## VENDOR SERVICE PUBLICATION

SUBJECT: Oil Pump Impeller and Drive Replacement; AVCO Lycoming Service Bulletin No. 385C dated October 3, 1975 (attached).

Service Bulletin No. 385C  
(Supersedes Service Bulletin No. 385B)  
Engineering Aspects are  
FAA (DEER) Approved

SUBJECT: Oil Pump Impeller and Drive Replacement

Figure 1. Interior View of Accessory Housing Showing Location of Cotter Pin in Oil Pump Idler Shaft

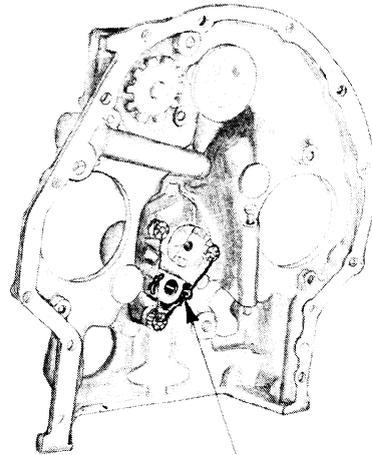
INSPECTION: Applicable remanufactured engines shipped after December 21, 1972 should be inspected to determine if this modification is required: first of all, if the engine log book indicates the engine has not been modified in accordance with Service Instruction No. 1230 or No. 1272, proceed to remove the accessory drive cover from the mounting pad at the lower right side of the accessory housing to obtain access to the area between the crankcase and the accessory housing. On some engines this accessory drive pad is not machined, in this event it will be necessary to remove either the left magneto or the \*fuel pump to obtain access to the area between the crankcase and the accessory housing. Regardless of which accessory pad is used, determine if the oil pump idler gear is secured with a cotter pin at the location shown in figure 1. This can be accomplished using an inspection mirror, preferably an illuminated one. If the cotter pin is visible, it is unnecessary to perform the modification required by this bulletin.

IF IDLER SHAFT IS SECURED WITH A COTTER PIN AT THIS LOCATION MODIFICATION IS NOT REQUIRED

Figure 2. Oil Pump Drive Assembly

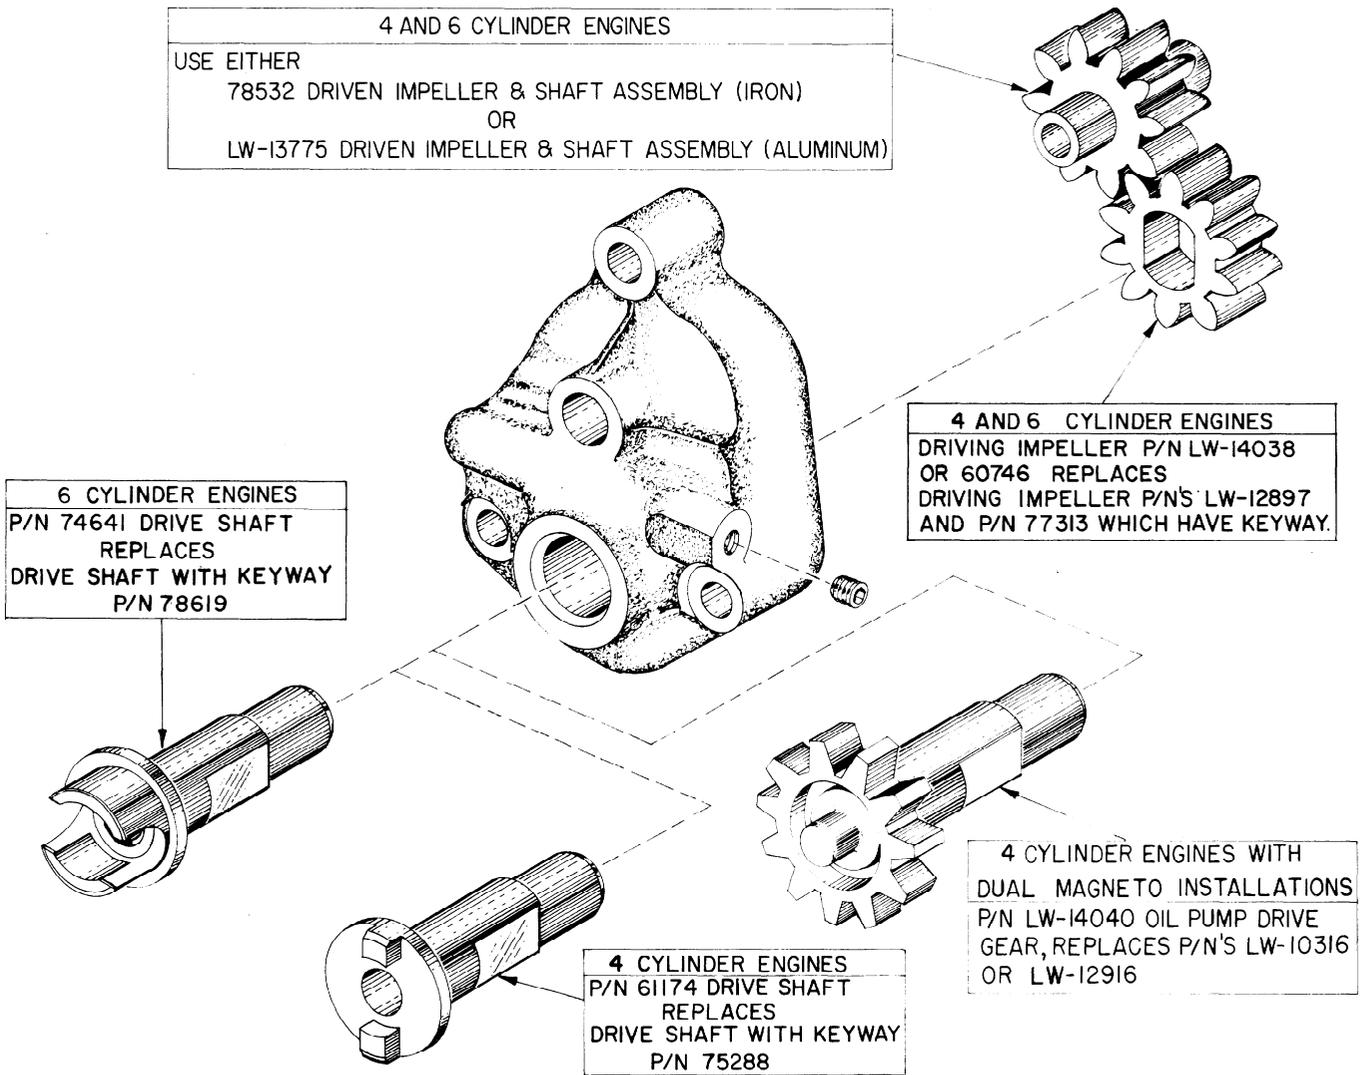
This modification consists of replacing the oil pump drive shaft and drive impeller to eliminate the Woodruff key drive which has proven to be the cause of excessive wear in the keyway of the hardened drive impeller. Therefore, it is recommended that all of the applicable engines listed in the chart, as well as any others that may have been modified in accordance with Service Instruction No. 1272, use the following procedure for parts replacement.

3. Reassemble the oil pump using the new drive shaft and drive impeller supplied with the kits shown in the following "Parts Data" section. See figure 2. Be sure all of the parts are lubricated thoroughly during assembly.

- LW-14131                    Oil Pump Shaft Replacement Kit (4 cylinder engines)  
consists of: (1) 61174 oil pump drive shaft, (1) LW-14038 or 60746 drive impeller

- LW-14132                    Oil Pump Shaft Replacement Kit (4 cylinder, dual drive magneto engines)  
consists of: (1) LW-14040 oil pump drive gear, (1) LW-14038 or 60746 drive impeller

- LW-14133                    Oil Pump Shaft Replacement Kit (6 cylinder engines)  
consists of: (1) 74641 oil pump drive shaft, (1) LW-14038 or 60746 drive impeller
